Docket Item #6
Development Site Plan #2007-0011
Special Use Permit # 2008-0084
Encroachment # 2008-0005
532 North Washington Street – Office Building

Purpose of Application
Approval of a two-story addition to an existing office building at the southwest corner of N. Washington Street and Pendleton Street.

DSP #2007-0011
SUP #2008-0084
ENC #2008-0005

Figure 2: Site Plan

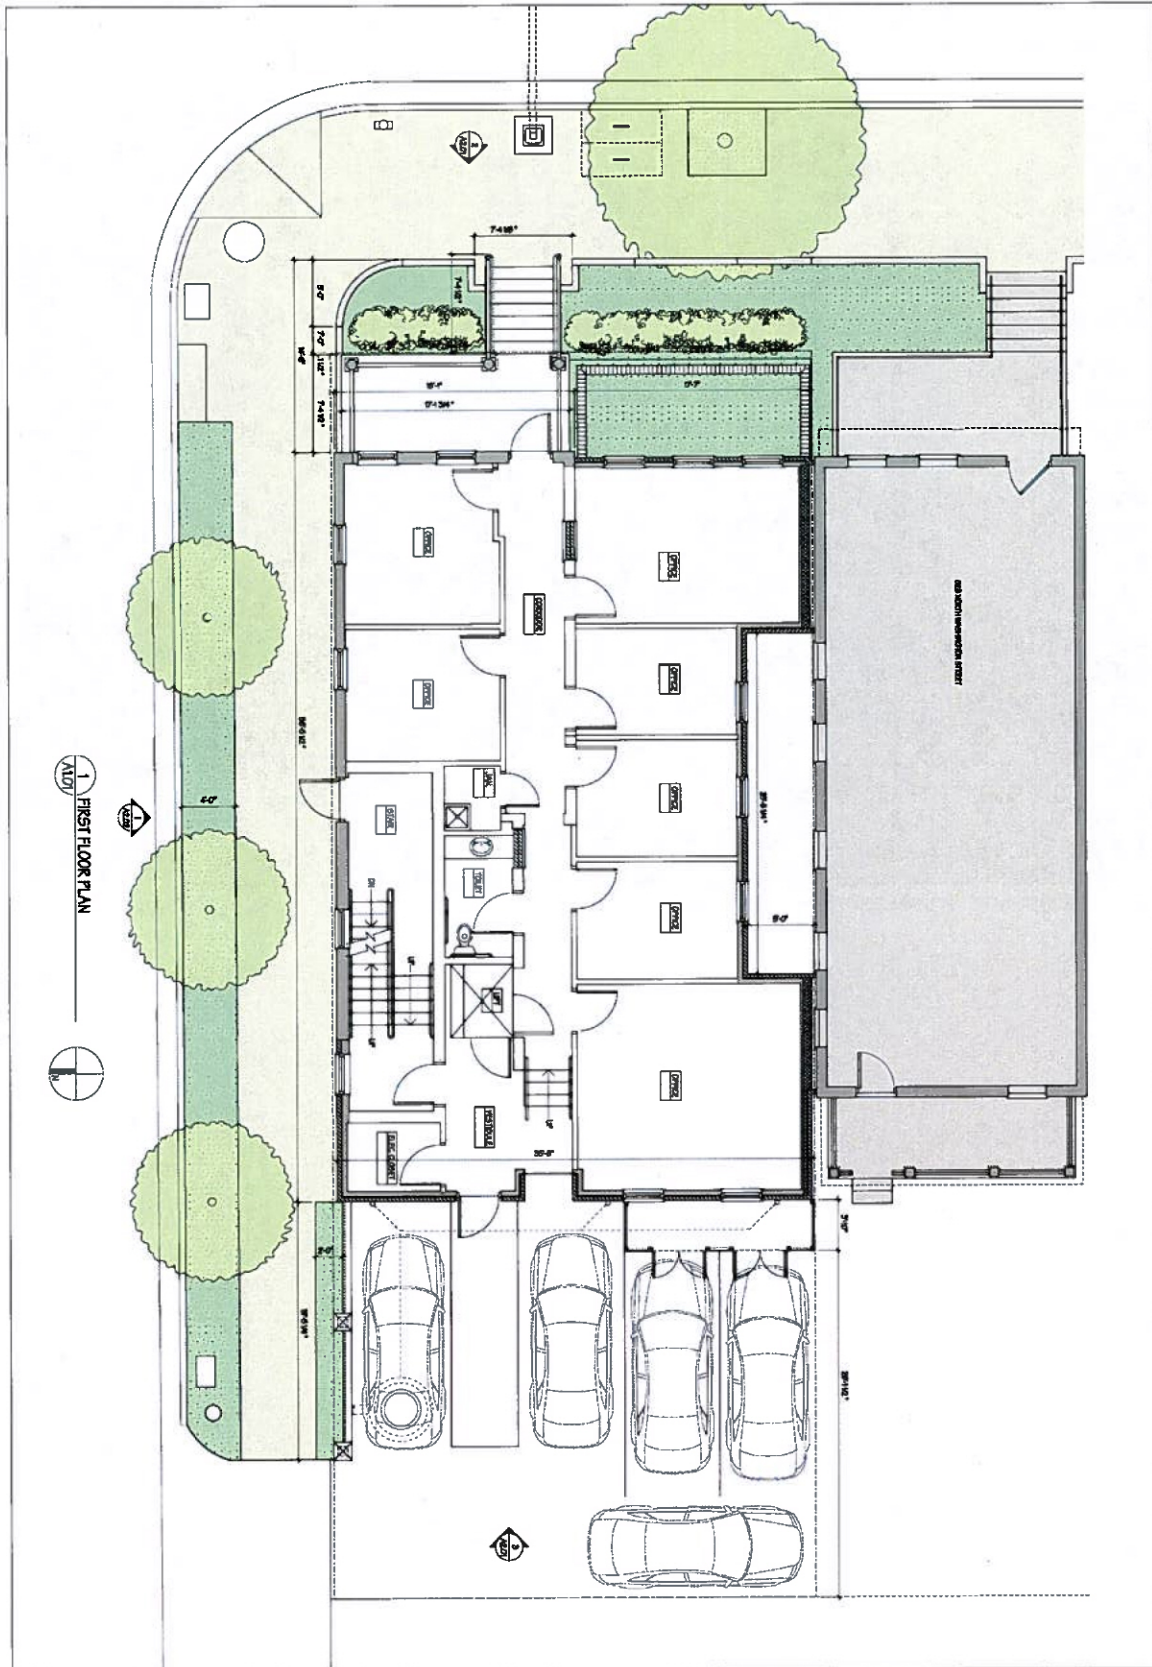
Therefore, staff has recommended that the site plan be revised to provide two standard size parking spaces that meet the zoning requirements and a handicap space. A parking reduction of six spaces would be required.

Finally, the special use permit can not approve a reduction to less parking than is currently provided. Although the existing conditions plan shows five spaces in the rear lot, these spaces are only 6.5-7 feet wide and would not be considered a space per the Zoning Ordinance. Furthermore, a handicap accessible space is not provided in the lot as is required by ADA. Therefore, a reduction that allows the parking space size to comply with the Zoning Ordinance while also bringing the site into compliance with ADA standards would be acceptable.

11. The following modifications to the Landscape Plan and supporting drawings are required:
- a. Provide species cultivar for *Acer rubrum* as "Red Sunset". Street trees shall be Shade Trees Type II, 3.5-4.0 inches in caliper in compliance with *City of Alexandria Landscape Guidelines*.

- b. Extend grass planting strip along Pendleton St. approximately 6 feet east/toward N. Washington St. to align with face of proposed porch.
 - c. Provide 4 equally spaced street trees along Pendleton Street

37. The site plan shall be revised to provide three (3) standard parking spaces (including one handicap accessible space) in the rear parking lot. The applicant shall show the parking layout per the requirements of the Zoning Ordinance and show turning movements of standard vehicles in the parking lot per the latest AASHTO vehicular guidelines and to the satisfaction of the Director of T&ES. (P&Z) (T&ES)
